UNITED STATES PATENT AND TRADEMARK OFFICE

APPLICATION NO.	FILING DATE	FIRST NAMED INVENTOR	ATTORNEY DOCKET NO.	CONFIRMATION NO.
10/625,734	07/24/2003	Naoto Fujishima	1639.1008D	8062

Office Action Summary

DETAILED ACTION***Drawings***

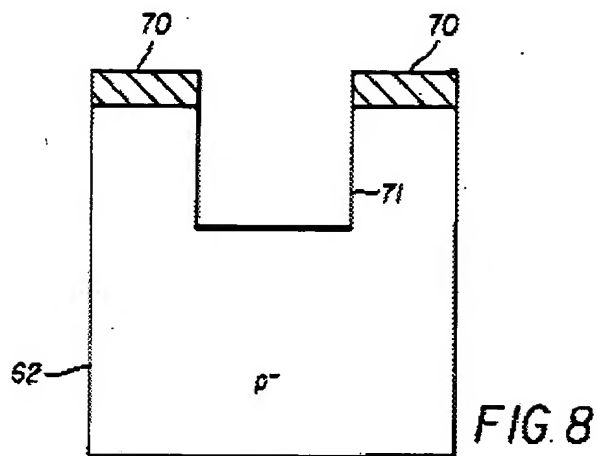
forming a trench **71** in a surface region of a semiconductor substrate **62**, of a first conductivity type (p-type) (col. 7, lines 6-17 and FIG. 8);

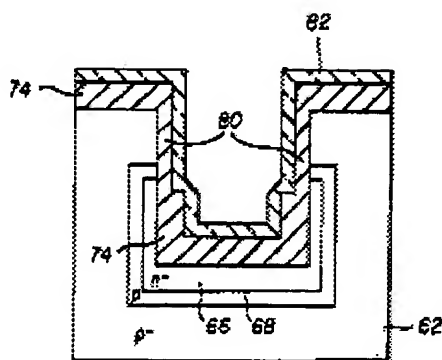
forming a gate insulating film 80, having a uniform thickness, along a side surface and a bottom surface of the trench and inside the trench and forming a first conductor 82 along a surface of the gate insulating film (col. 7, lines 19-31 and FIG. 13a),

etching back the first conductor in an active region so that the first conductor remains only in side surface regions of the trench (col. 7, lines 32-57 and FIG. 15a);

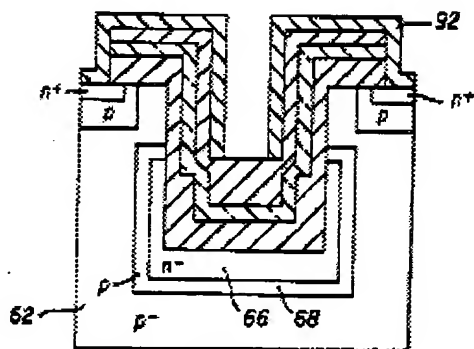
forming a base region (**p**) of, the first conductivity type (p-type), and a source region (**n+**), of the second conductivity type (n-type), in a surface region of the semiconductor substrate outside the trench (col. 7, lines 32-57 and FIG. 16b);

FIG. 15b

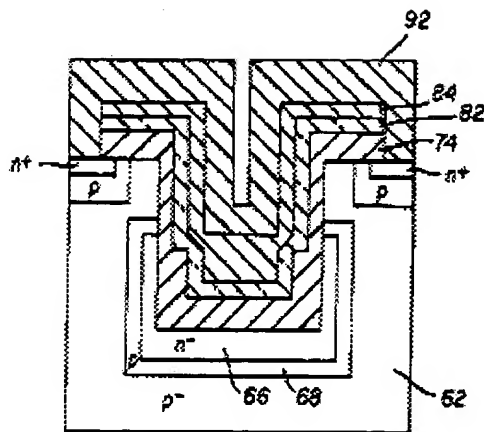
forming an interlayer dielectric 84 inside the first conductor (col. 7, lines 19-30 and FIG. 15b);

FIG. 16a

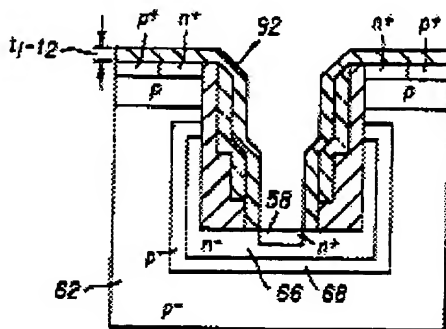
selectively removing a bottom of the interlayer dielectric in the active region;
forming a drain region 58 of, the second conductivity type (n-type), at the bottom of the trench (col. 7, lines 32-57 and FIG. 16a); and

FIG. 18a

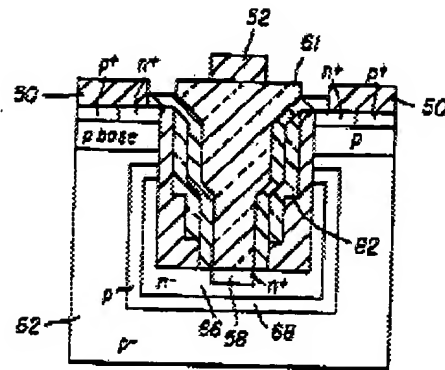
forming a second conductor **61** in the trench, the second conductor electrically connecting to the drain region (col. 7, lines 32-57 and FIG. 18a).

FIG. 18b

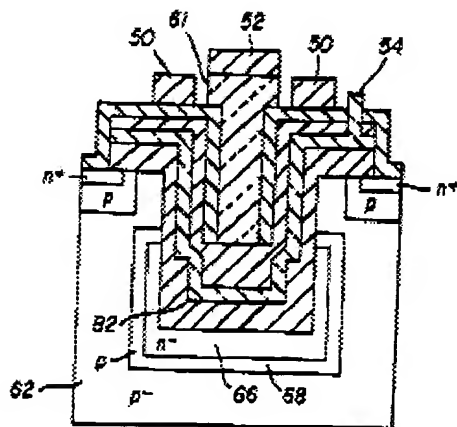
In re claim 2, Fujishima discloses that the method for manufacturing a semiconductor device of claim 1, further comprising: forming an interlayer dielectric 80 on a surface of the semiconductor substrate 62, opening contact holes through the interlayer dielectric (col. 7, lines 32-57), forming a gate electrode 54 that electrically connects to the first conductor 82, a drain electrode 52 that electrically connects to the second conductor 61, and a source electrode 50 that electrically connects to the source region (FIGS. 18a-b).
